ORIGINATION FORM

Proposed Revisions to a Standard Plans Index
(Please provide all information – Incomplete forms will be returned)

Index Number: **17515**
Sheet Number (s): 1, 2, 6, 7, 8
Index Title: Standard Aluminum Lighting

LAST REVISION 11/01/16	REVISION	DESCRIPTION:	 FY 2017-18 DESIGN STANDARDS	STANDARD ALUMINUM LIGHTING	INDEX NO. 715-002-17515	SHEET NO. 1 of 8
---------------------------	----------	--------------	--	----------------------------	----------------------------	---------------------

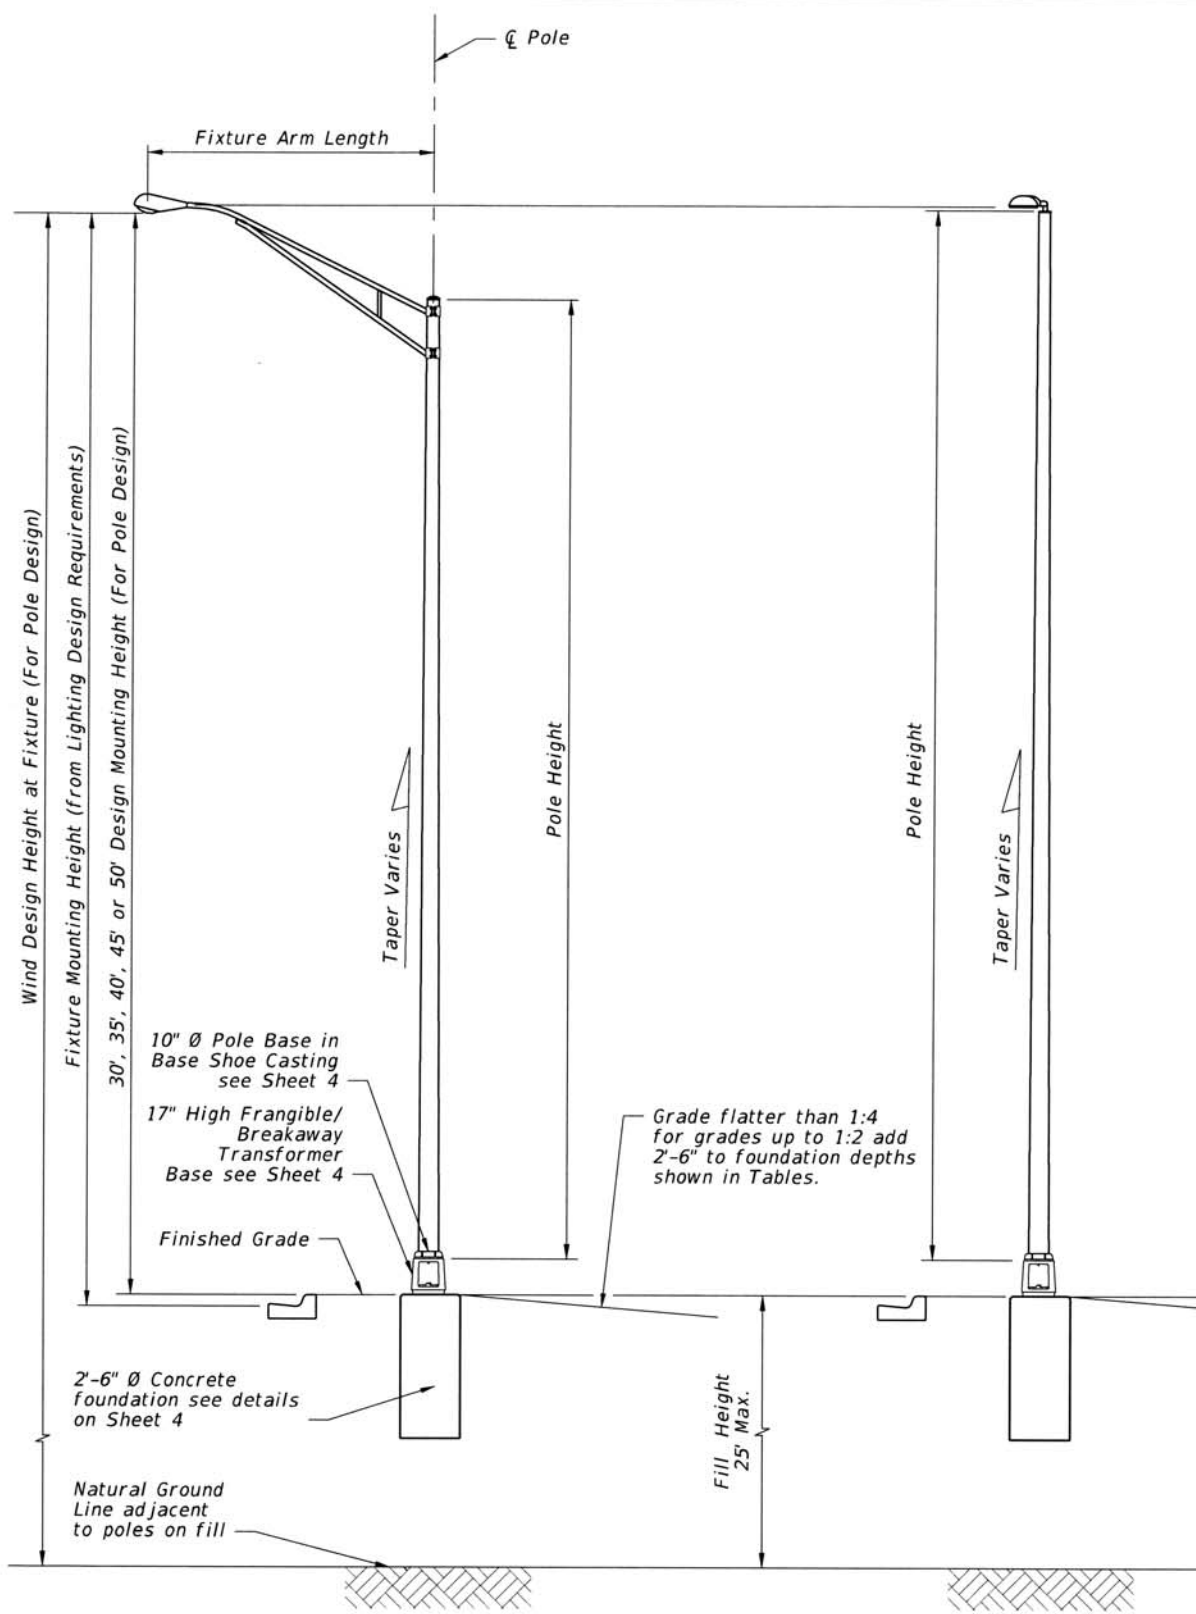
~~7. Payment Note: Include the cost of the EJB in the cost of the median barrier or Traffic Railing it is embedded in.~~ 7. Embedded Junction Boxes: Reference Spec G35

8. ← Added wind loads note

LAST REVISION 11/01/16	DESCRIPTION:		FY 2017-18 DESIGN STANDARDS	STANDARD ALUMINUM LIGHTING	INDEX NO.	SHEET NO.
					715-002-17515	2 of 8

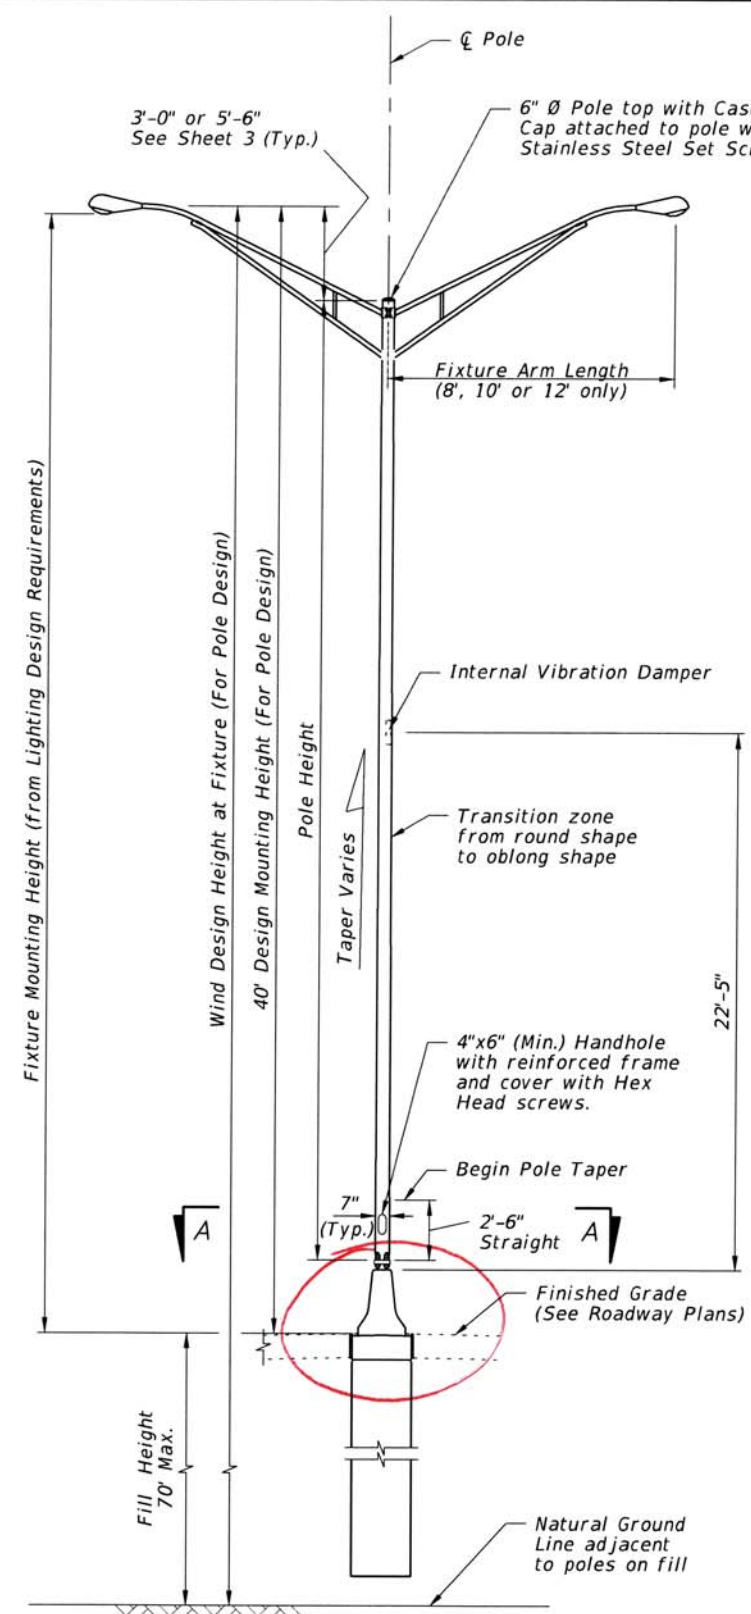
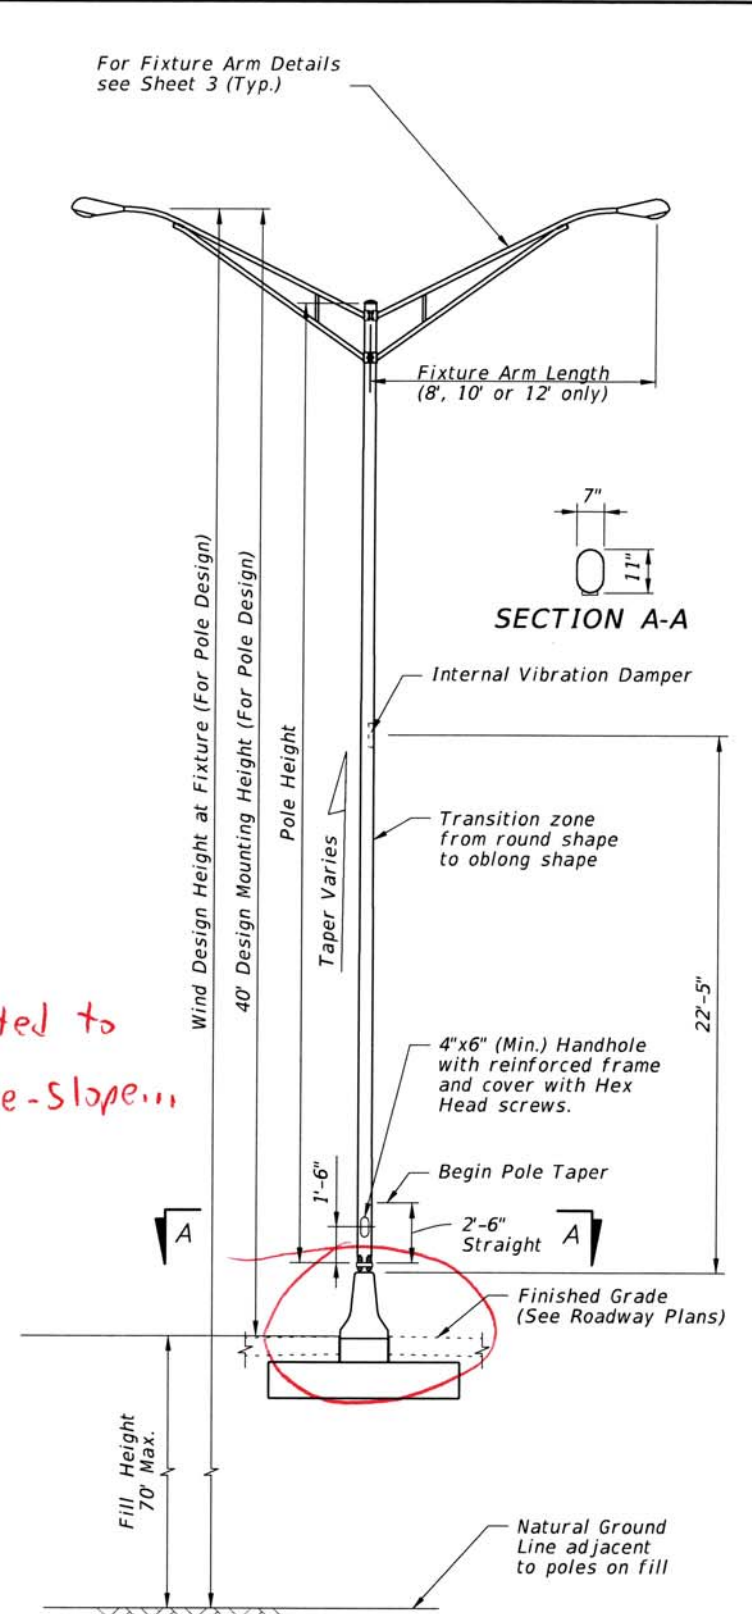
updated to Single-Slope...

SPREAD FOOTING DETAILS FOR MEDIAN BARRIER MOUNTED ALUMINUM LIGHT POLE

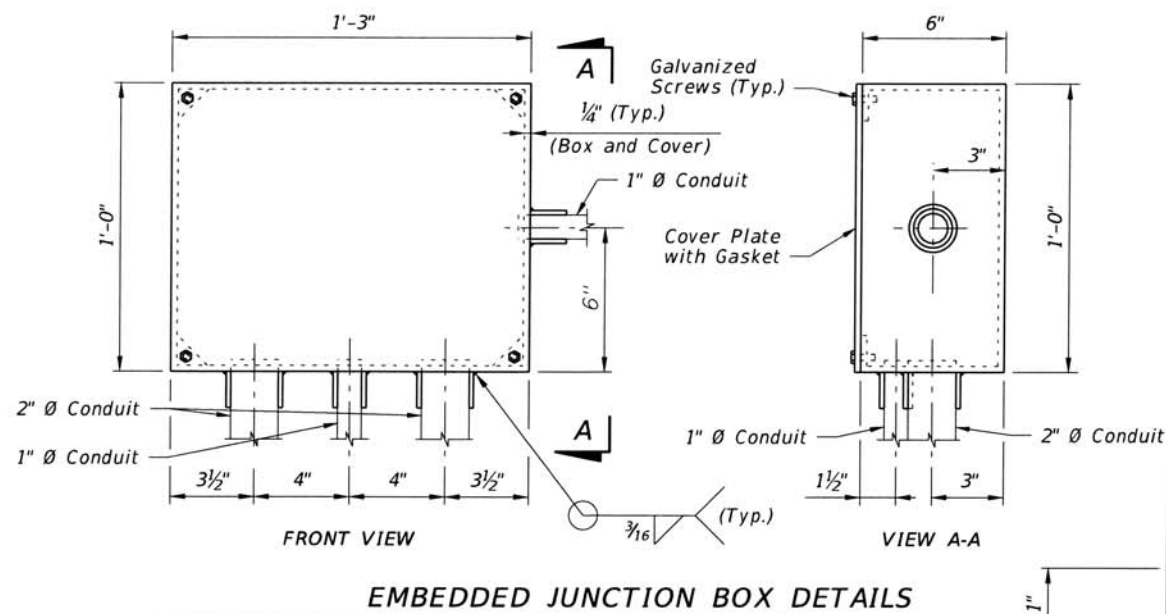
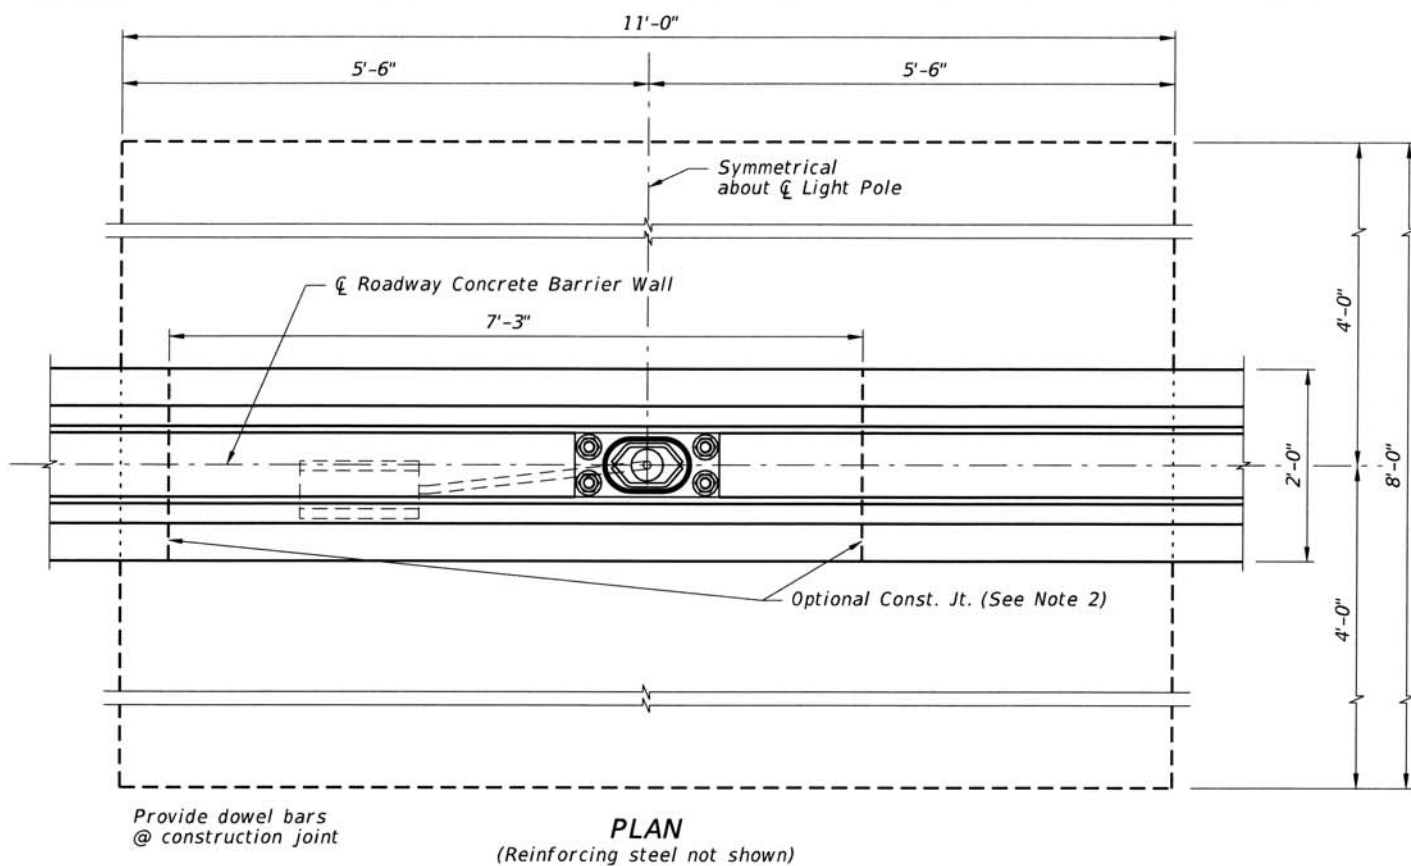
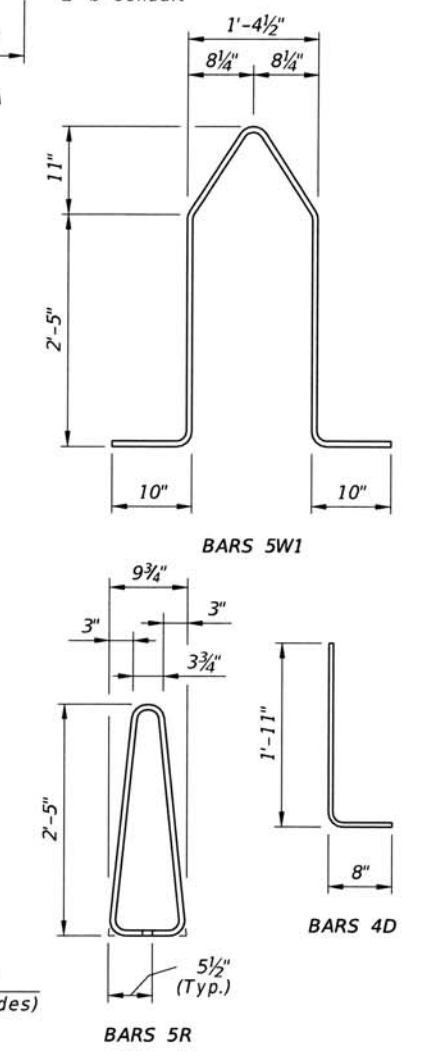
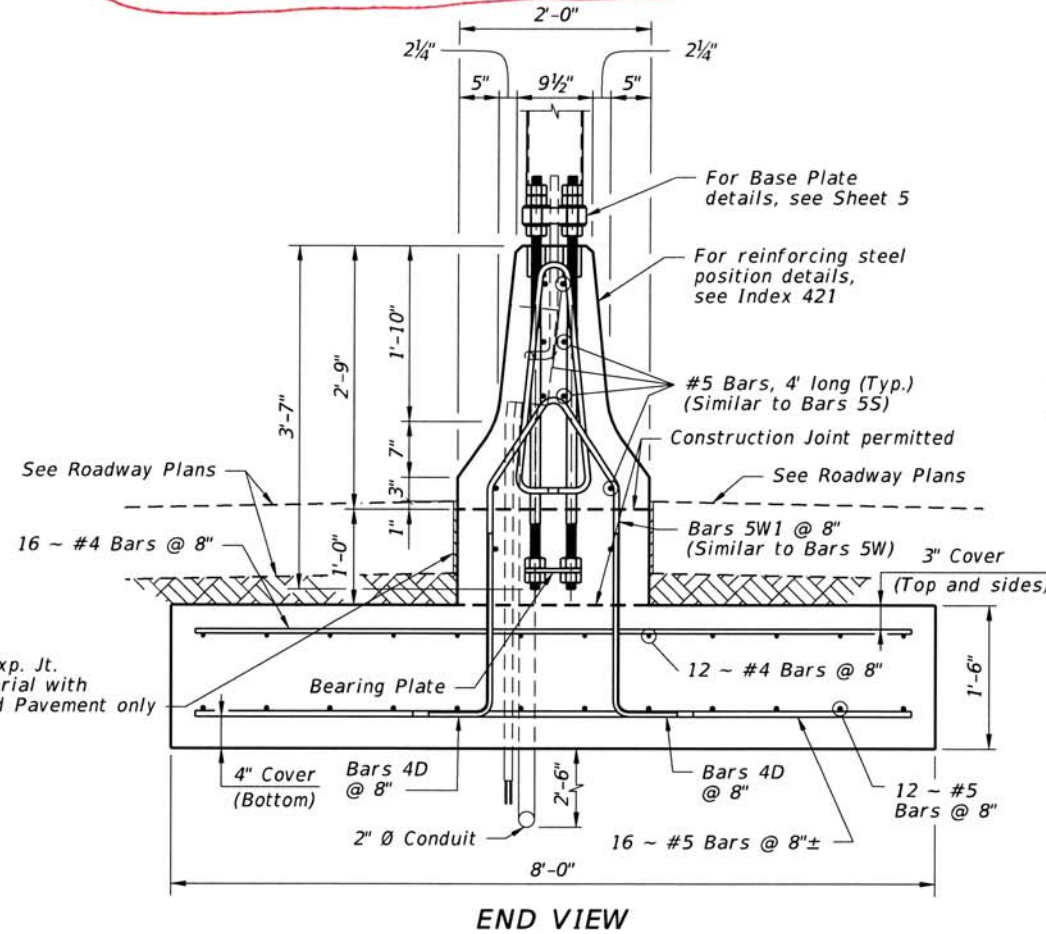
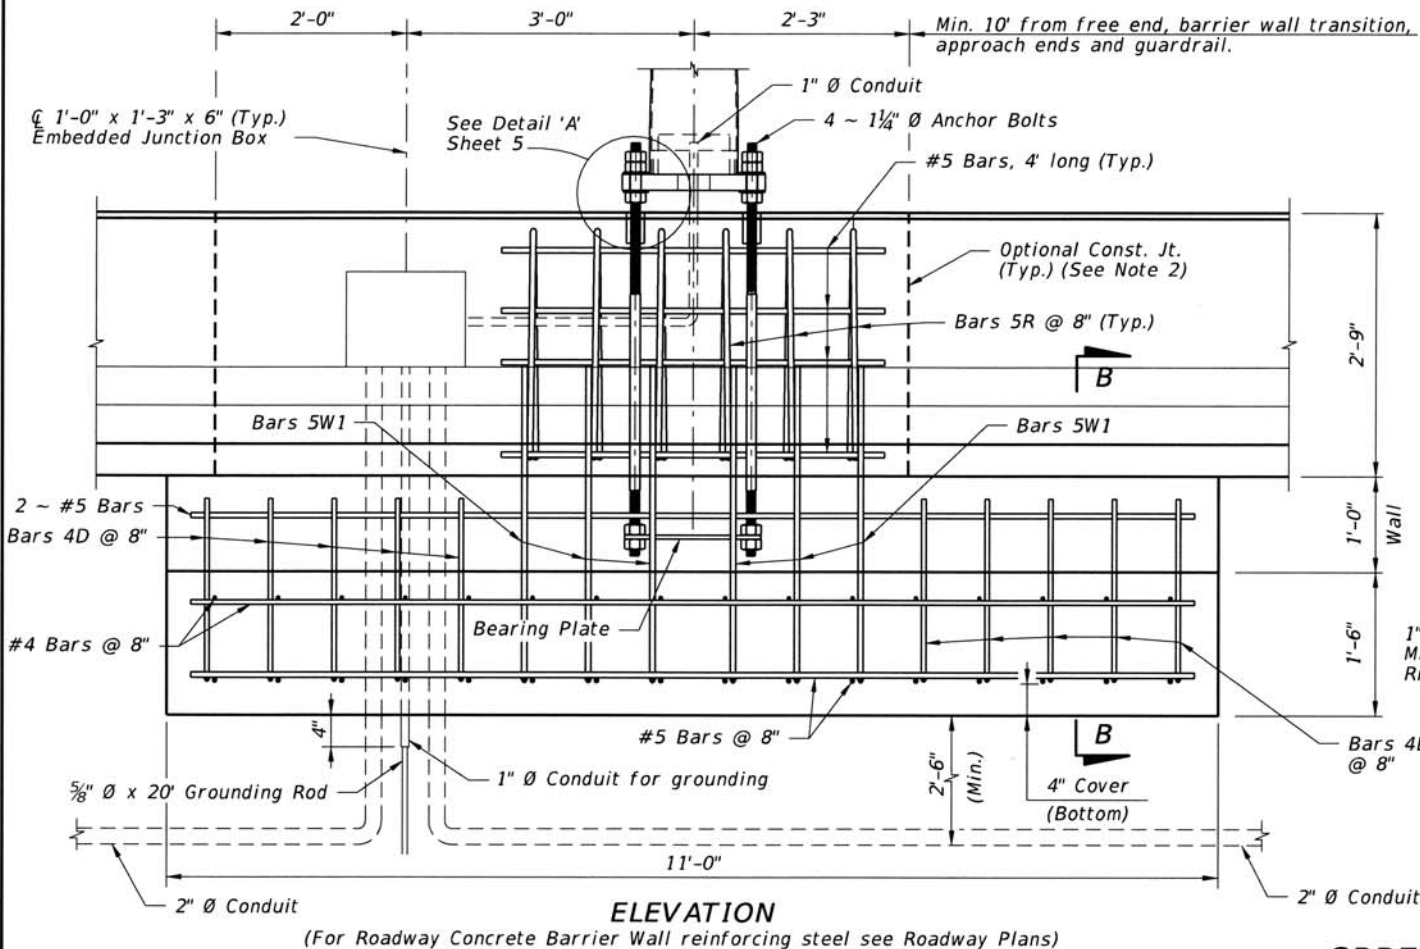
**Revised Plan, Elevation, End View, and Bar Bending Diagrams for Single-Slope Concrete Barriers..*
